**TAXIWAY LIMA EXTENSION AND DECOMMISSIONING OF GA RUNWAY 4R-22L AND TAXIWAY ECHO
BATON ROUGE METROPOLITAN AIRPORT**

ADDENDUM NO. 3

DATE ISSUED: JULY 24, 2024

OVERALL CONSTRUCTION SAFETY PLAN AND AIRPORT SAFETY PLAN
SCALE: 1" = 500'

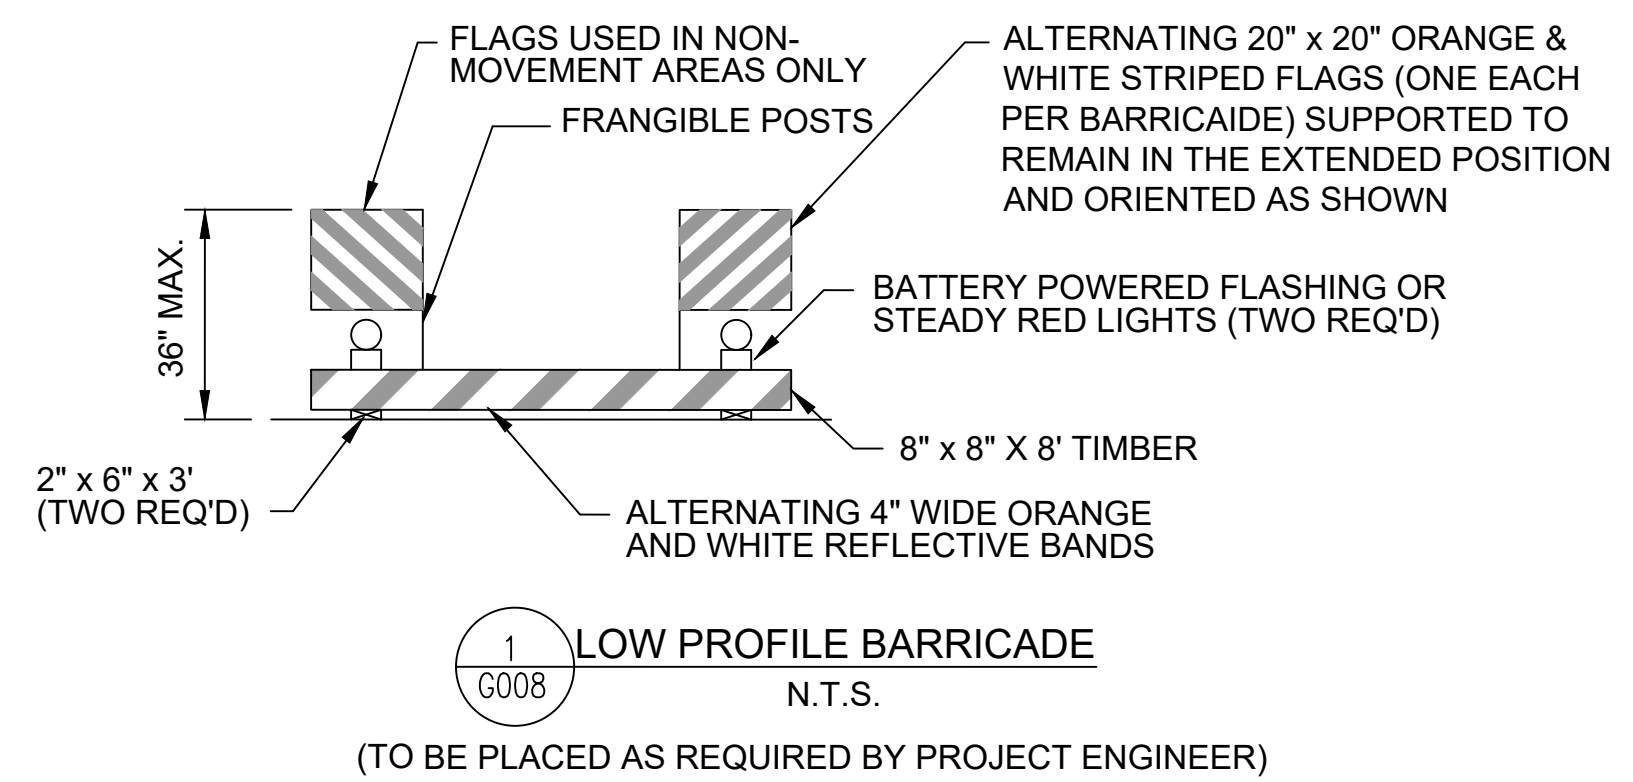
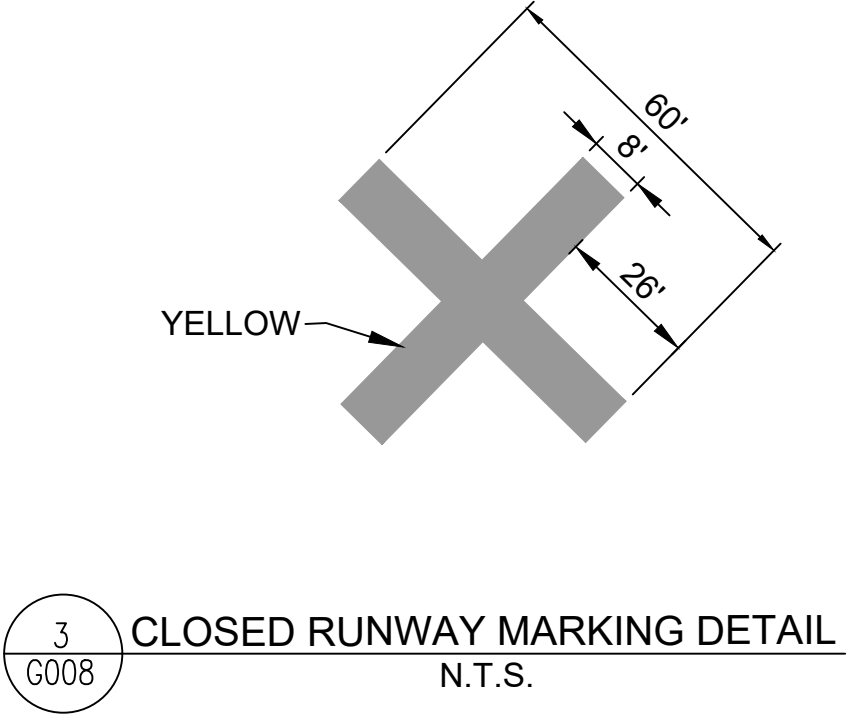
- CROSS TO BE DESIGNED TO BE SUBMITTED FOR APPROVAL.
- CONTRACTOR TO PROVIDE ONE (1) MARKER FOR EACH END OF THE RUNWAY FOR A TOTAL OF TWO(2). FOR DURATION OF THE PROJECT.

- THE CONTRACTOR SHALL FURNISH TWO (2) LIGHTED RUNWAY CLOSURE MARKERS, SHERWIN INDUSTRIES OR EQUAL, THAT MEETS OR EXCEEDS FAA TECHNICAL REPORT DOT/FAA/CT-TN87/3, OR LATEST UPDATE, FOR THE DURATION OF THE PROJECT.
- CONTRACTOR SHALL OPERATE AND MAINTAIN THE RUNWAY MARKERS IN GOOD CONDITION AND PROVIDE ALL FUEL, LUBRICANTS AND REPLACEMENT BULB (UL TESTED AND APPROVED) FOR THE DURATION OF THE PROJECT.

TAXIWAY LIMA EXTENSION
TYPICAL SECTION -- TXWY L EXTENSION

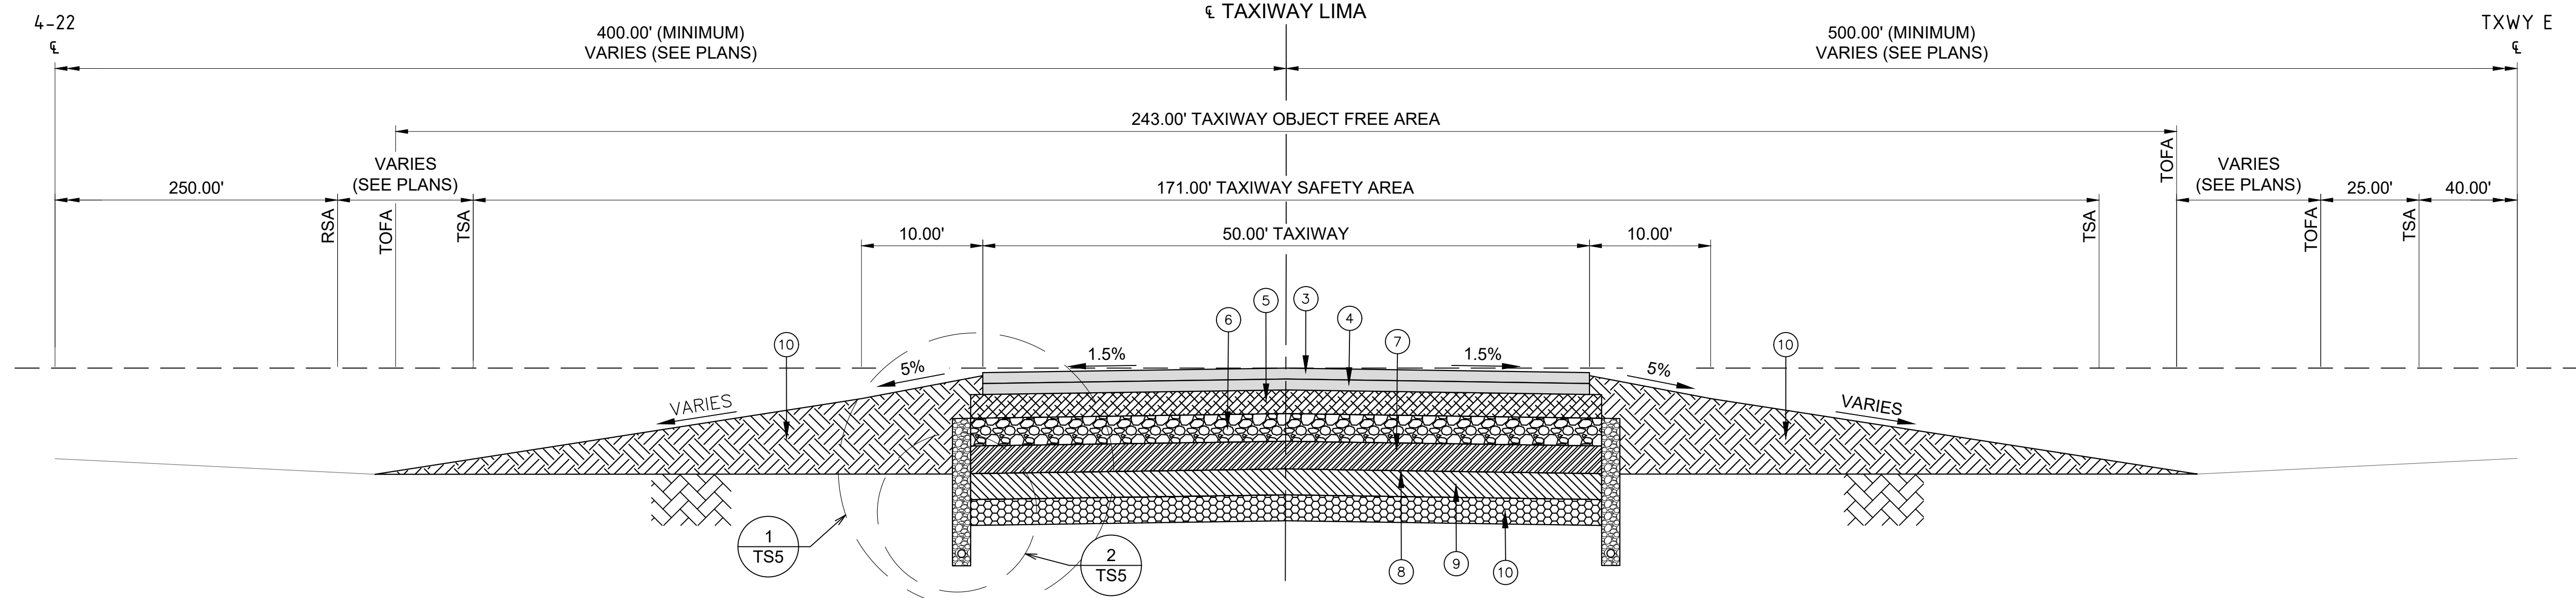
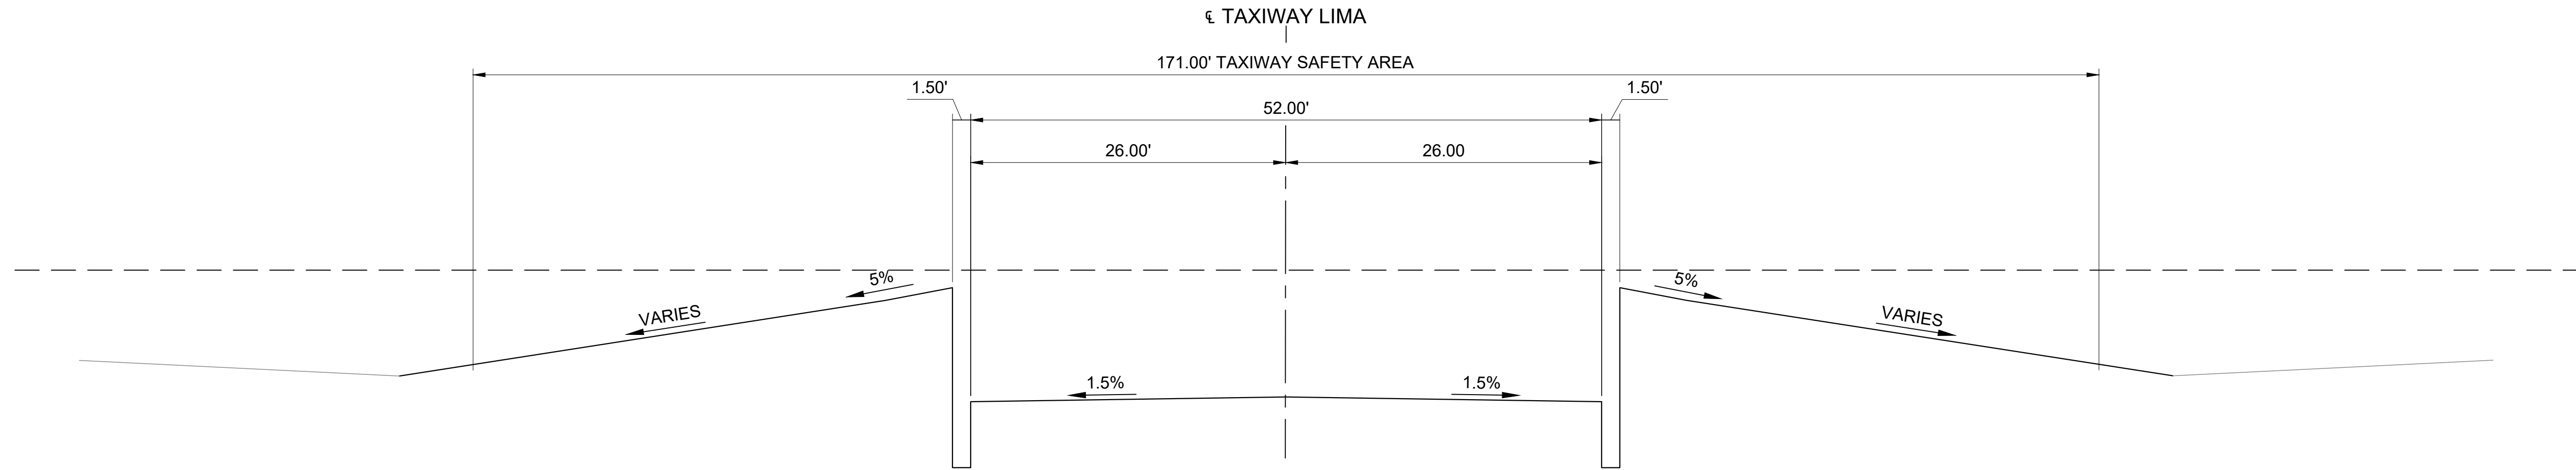
1
TS2
PROPOSED TAXIWAY GRADING SECTION
SCALE: NOT TO SCALE
STA. 520+85.41 TO STA. 534+01.96
STA. 534+76.96 TO STA. 537+64.05
STA. 539+14.05 TO STA. 542+48.12
STA. 543+39.60 TO STA. 557+81.83
STA. 558+55.83 TO STA. 582+82.50

2
TS2
PROPOSED TAXIWAY TYPICAL SECTION - BID ALTERNATE 1
SCALE: NOT TO SCALE
STA. 520+85.41 TO STA. 534+01.96
STA. 534+76.96 TO STA. 537+64.05
STA. 539+14.05 TO STA. 542+48.12
STA. 543+39.60 TO STA. 557+81.83
STA. 558+55.83 TO STA. 582+82.50

- NOTES:**
1. CONTRACTOR SHALL REMOVE STANDING WATER FROM THE SUBGRADE DURING CONSTRUCTION BY GRADING, DITCHING, PUMPING, OR WHATEVER MEANS ARE NECESSARY TO KEEP THE SUBGRADE DRY.
 2. SEE PLANS AND GEOMETRIC LAYOUT SHEETS FOR EXACT WIDTHS OF PAVEMENT, TSA, AND TOFA AT VARIOUS LOCATIONS.
 3. SEE PROPOSED GRADING SHEETS AND CROSS SECTIONS FOR GRADING DETAILS.

TAXIWAY LIMA EXTENSION
TYPICAL SECTION -- TXWY L EXTENSION

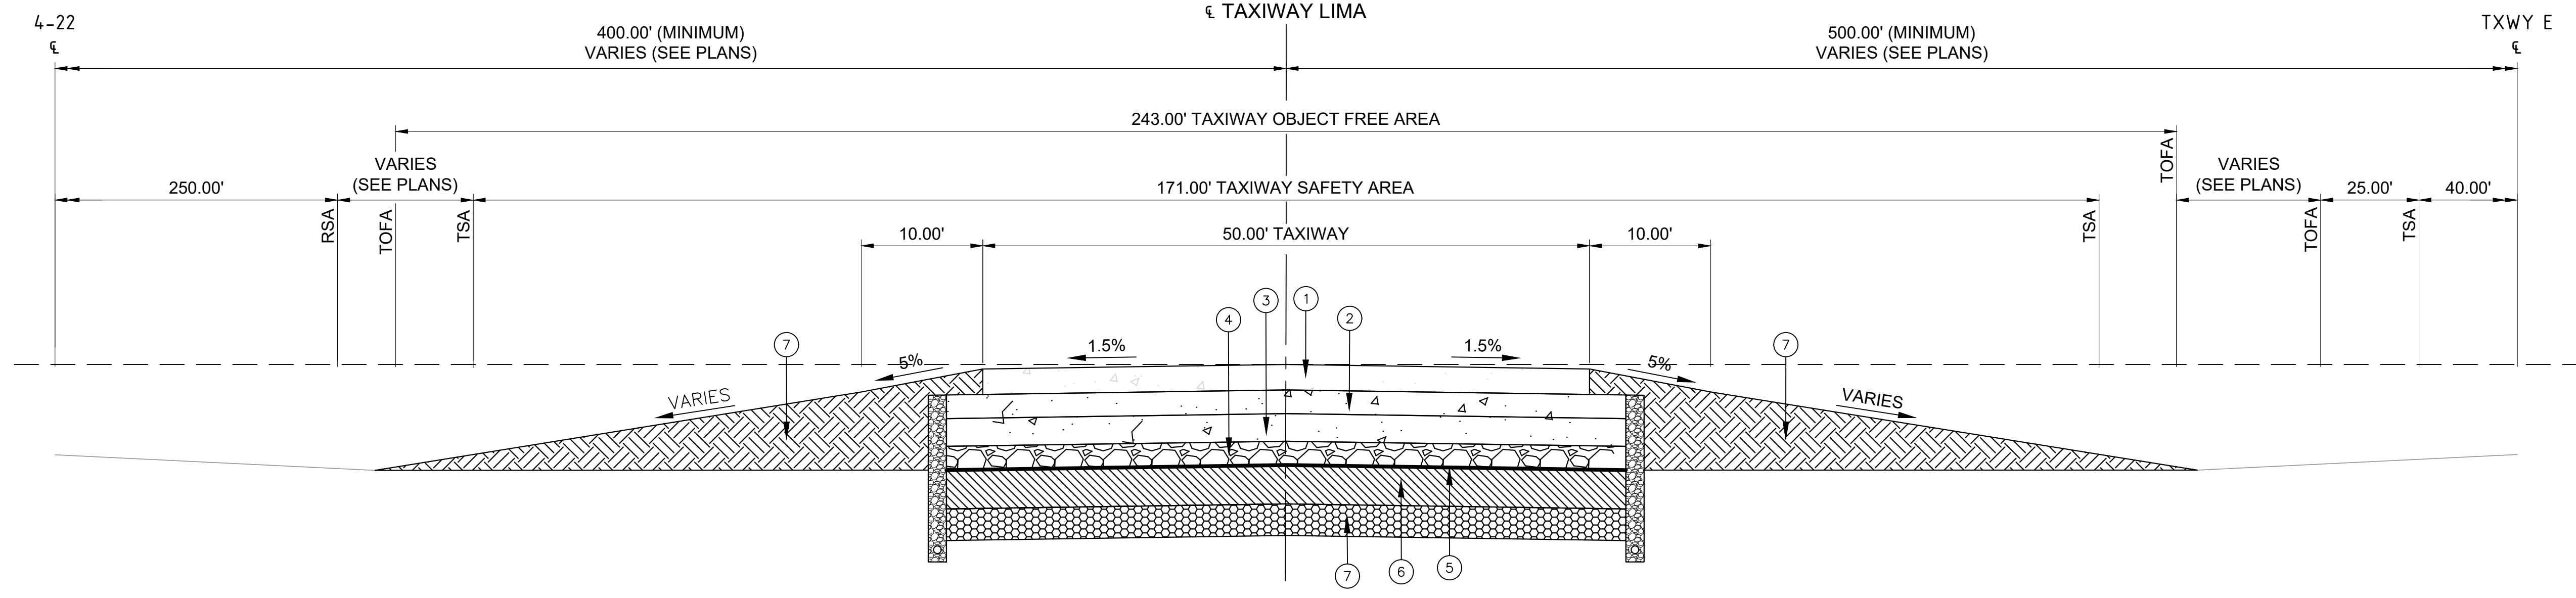
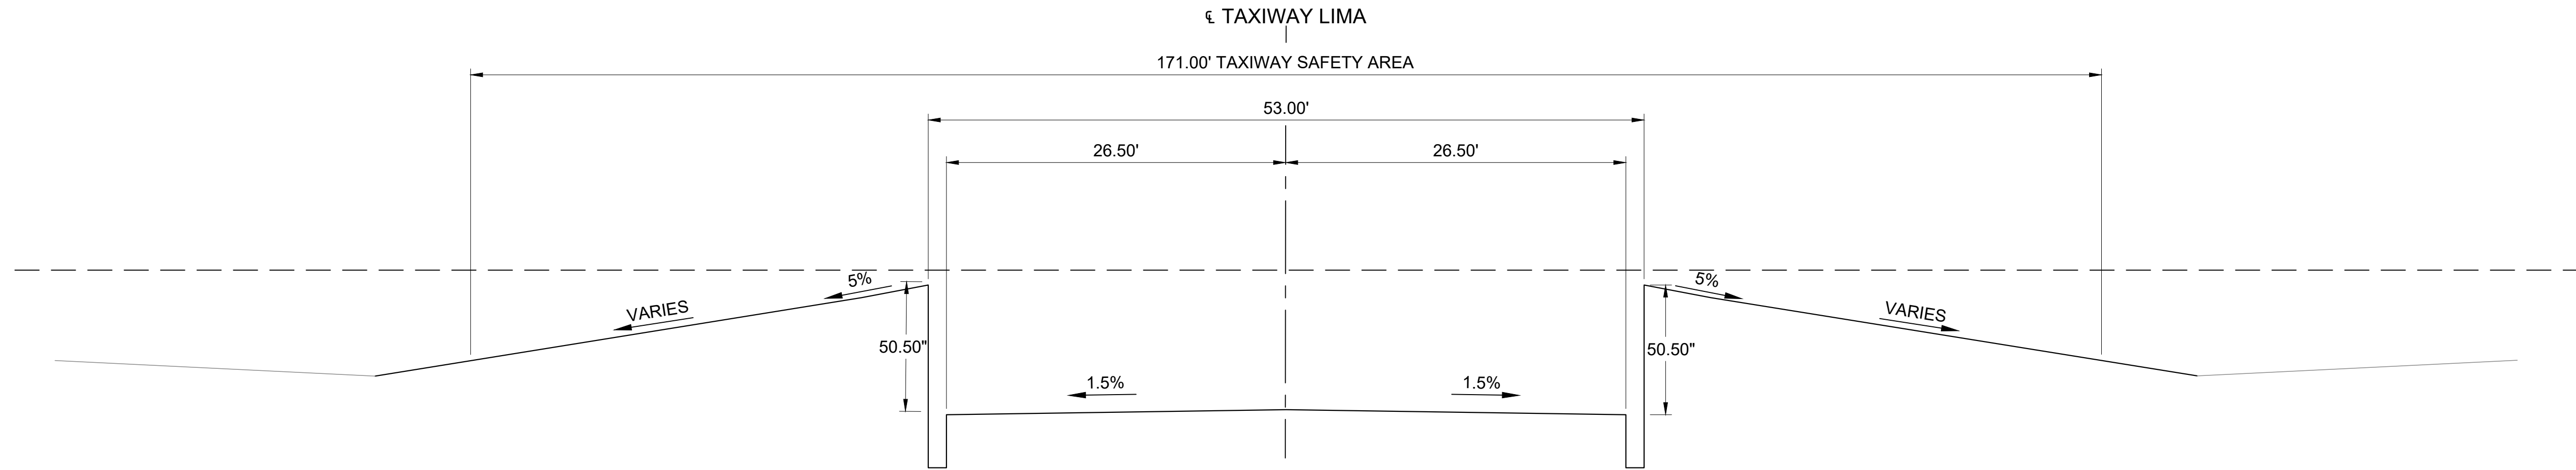
1
TS2.5
PROPOSED TAXIWAY GRADING SECTION
SCALE: NOT TO SCALE
STA. 520+85.41 TO STA. 534+01.96
STA. 534+76.96 TO STA. 537+64.05
STA. 539+14.05 TO STA. 542+48.12
STA. 543+39.60 TO STA. 557+81.83
STA. 558+55.83 TO STA. 582+82.50

2
TS2.5
PROPOSED TAXIWAY TYPICAL SECTION - BASE BID
SCALE: NOT TO SCALE
STA. 520+85.41 TO STA. 534+01.96
STA. 534+76.96 TO STA. 537+64.05
STA. 539+14.05 TO STA. 542+48.12
STA. 543+39.60 TO STA. 557+81.83
STA. 558+55.83 TO STA. 582+82.50

- NOTES:**
1. CONTRACTOR SHALL REMOVE STANDING WATER FROM THE SUBGRADE DURING CONSTRUCTION BY GRADING, DITCHING, PUMPING, OR WHATEVER MEANS ARE NECESSARY TO KEEP THE SUBGRADE DRY.
 2. SEE PLANS AND GEOMETRIC LAYOUT SHEETS FOR EXACT WIDTHS OF PAVEMENT, TSA, AND TOFA AT VARIOUS LOCATIONS.
 3. SEE PROPOSED GRADING SHEETS AND CROSS SECTIONS FOR GRADING DETAILS.
